## Product Change Notification / ASER-23WWAI681

CCB 4235 Final Notice: Qualification of MMT as a new final test site for selected Atmel AT27C/BV/LVxxxPU/JUxxx products

**PCN # ASER-23WWAI681**  
**CCB 4235\_Pre and Post Change Summary**

## PLCC 32 COVER TAPE (Width: 24mm)

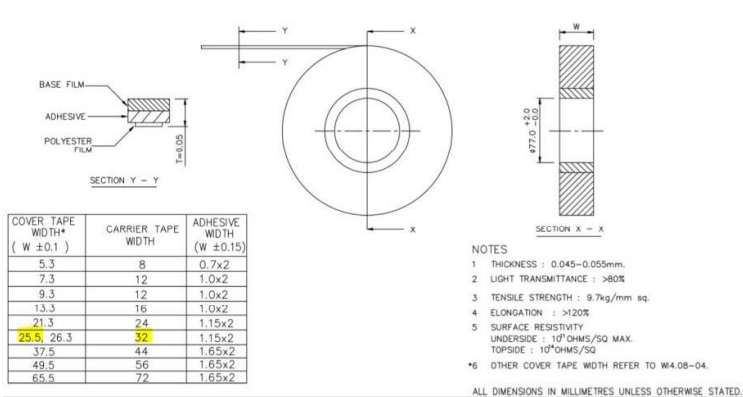
# MPHL COVER TAPE

| Carrier Width | Supplier | MCHP P/N | Supplier Part | Width "W" (mm) | Thickness (mm) | Sealing Mythology |
|---------------|----------|----------|---------------|----------------|----------------|-------------------|
| 24mm          | CPak     | 211894   | CP58 PSA      | 21.3 +/-0.1    | 0.050 ±0.010   | Pressure Seal     |

PLCC 32 COVER TAPE (Width: 24mm)

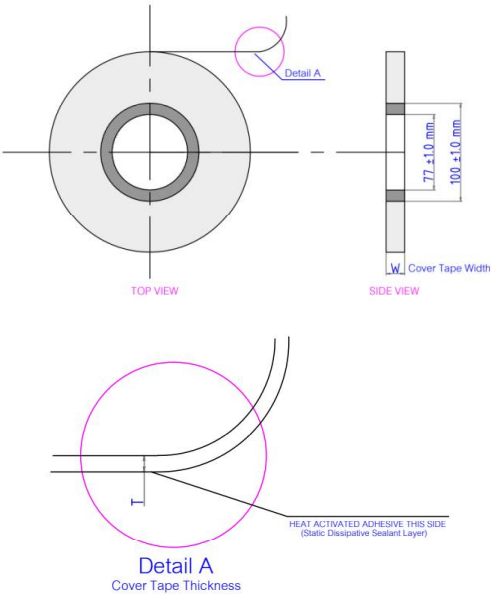
# MMT COVER TAPE

| Carrier Width | Supplier | MCHP P/N | Supplier Part | Width "W" (mm) | Thickness (mm) | Sealing Mythology |
|---------------|----------|----------|---------------|----------------|----------------|-------------------|
| 24mm          | Sumitomo | 22102002 | CSL-Z7302     | 21.0 +/- 0.1   | 0.050 ±0.010   | Heat Sealing      |

PLCC 44 COVER TAPE (Width: 32mm)

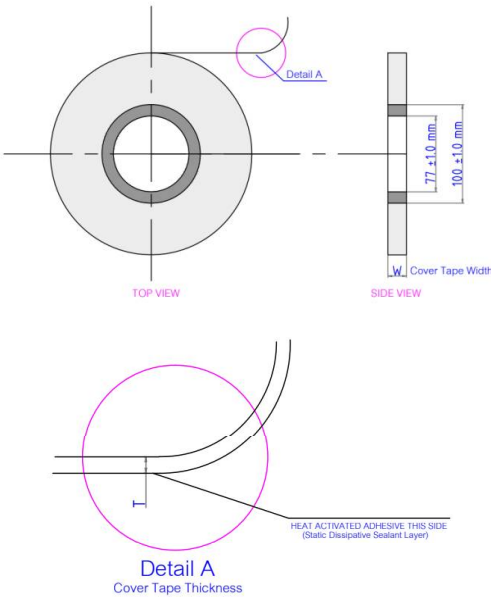
| Carrier Width | Supplier | MCHP P/N | Supplier Part | Width "W" (mm) | Thickness (mm) | Sealing Mythology |
|---------------|----------|----------|---------------|----------------|----------------|-------------------|
| 32mm          | Sumitomo | 22104401 | CSL-Z7302     | 25.5 +/- 0.1   | 0.050 ±0.010   | Heat Sealing      |

## PLASTIC REEL: WIDTH 24mm

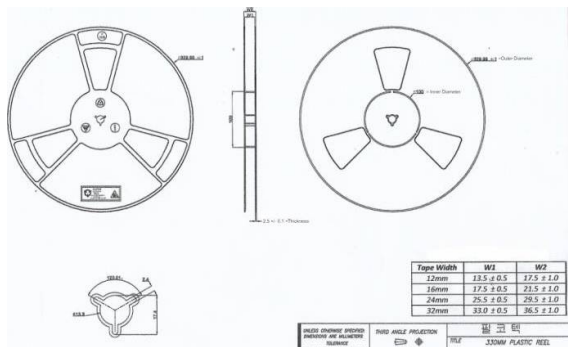
# MPHL PLASTIC REEL

| Width | MCHP P/N | Supplier Part | Hub           | Color |
|-------|----------|---------------|---------------|-------|
| 24mm  | 211696   | N/A           | 4inch (100mm) | White |

## PLASTIC REEL: WIDTH 32mm

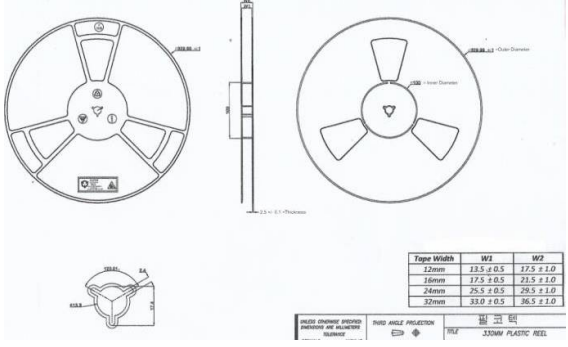
| Width | MCHP P/N | Supplier Part | Hub           | Color |
|-------|----------|---------------|---------------|-------|
| 32mm  | 211697   | N/A           | 4inch (100mm) | White |

## PLASTIC REEL: WIDTH 24mm

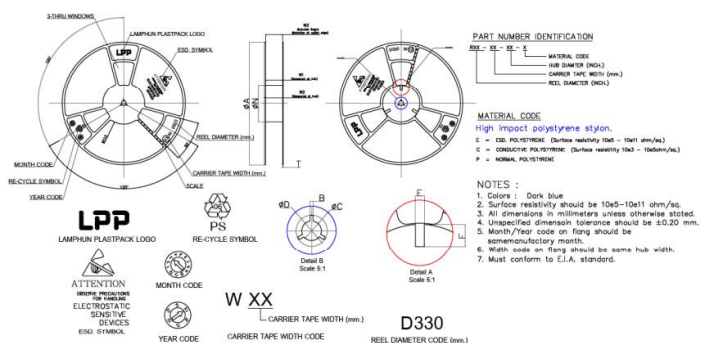
# MMT MPHL PLASTIC REEL

| Width | MCHP P/N | Supplier Part | Hub              | Color     |
|-------|----------|---------------|------------------|-----------|
| 24mm  | 23000024 | R13-24-04-E   | 4inch<br>(100mm) | Dark Blue |

## PLASTIC REEL: WIDTH 32mm

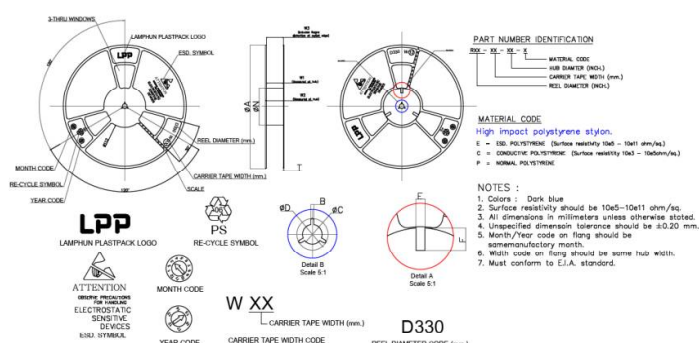
| Width | MCHP P/N | Supplier Part | Hub              | Color     |
|-------|----------|---------------|------------------|-----------|
| 32mm  | 23000023 | R13-32-04-E   | 4inch<br>(100mm) | Dark Blue |
